# Plastic Waste Reduction Standard

## JOINT VALIDATION AND VERIFICATION OF INCENTIVISING RECYCLING IN INDIA THROUGH THE GENERATION OF PLASTIC CREDITS

<b>Report Title</b>	Incentivising recycling in India through the generation of plastic credits
<b>Date of Issue</b>	27/10/2023
<b>Version</b>	2.0
<b>Report ID</b>	CC IPL1480/VERRA/VAL-VER/IRPC/20220808
<b>Prepared By</b>	Carbon Check (India) Private Limited
<b>Contact</b>	Carbon Check (India) Private Limited CIN: U74930DL2012PTC232495 Regd. Off: 2071/38, 2 <sup>nd</sup> Floor, Nai Wala, Karol Bagh, New Delhi - 110005 Corporate off: Unit No. 1701, Logix City Centre Office Tower, Plot No. BW-58, Sector-32 Noida, Uttar Pradesh Tel: +91 120 4373114 URL: <a href="http://www.carboncheck.co.in">www.carboncheck.co.in</a> e-mail: <a href="mailto:projects@carboncheck.co.in">projects@carboncheck.co.in</a>

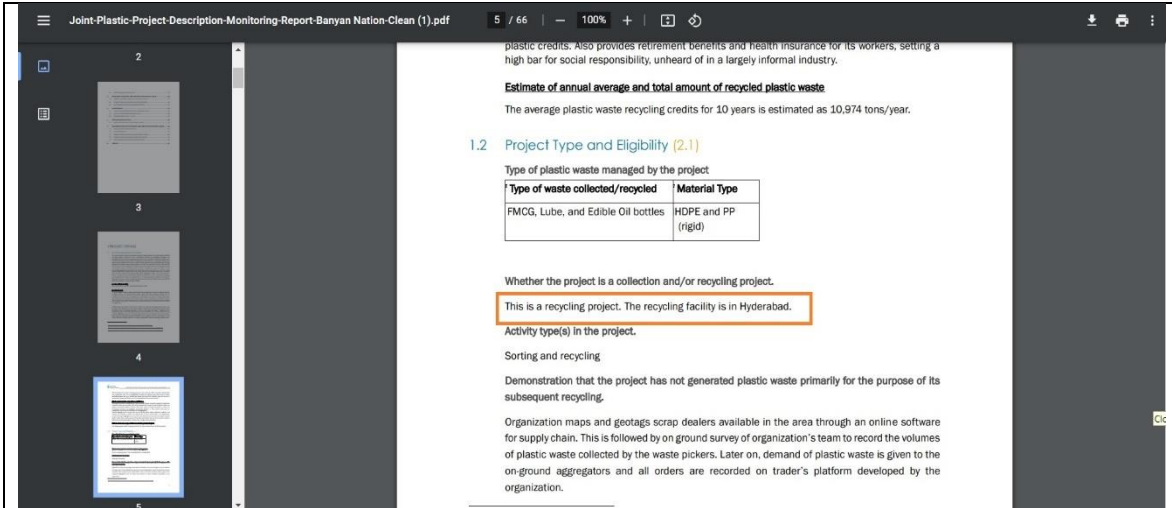
CL	01	Section no.	Verra Registry	Date: 20/03/2023
<b>Description of CL</b>				
<p>The VCS PD listed on the VERRA website is only aimed at the Recycling activity. However, the VCS PD submitted by the PP for joint validation and verification purposes includes collection activity as well apart from recycling.</p> <p>PP shall explain how the reason for this change and explain why the revised PD was not submitted to VERRA for re-listing as this a deviation from the project design that was approved by VERRA for the purpose of listing.</p>				
<b>Project participant response</b>				Date: 27/03/2023
PP would like to clarify that the collection part has been now removed from the revised JPD MR.				
<b>Documentation provided by project participant</b>				
Revised JPD MR				
<b>VVB assessment</b>				Date: 05/06/2023
<p>VVB has found that the collection part is removed from the revised JPD&amp;MR (v1.4), but PP needs to clarify why the revised JPD was not submitted to VERRA for re-listing as verification team has checked, v 1.2 of JPD is available on the VERRA site.</p> <p>Hence, CL01 has not been closed.</p>

PP would like to clarify during the initial listing we tried to get the project listed in verra with both collection and recycling. However, after comments from verra PP decided to list the project with recycling only and then later try with VVB for adding collection by explaining on-site scenario. It was found out during VVB audit of the project that collection is not possible, hence PP has removed the collection part again. Since the JPDMR is of version 1.4 right now. The listed one is version 1.2. but comprises of recycling only. See screenshot from listed JPDMR Page no-05, section 1.2-

Verra also guided us during initial listing that if we decide to add collection again then only, we must go through PCP for collection part again. Since it was listed with recycling part only. Below is the screenshot of the same.
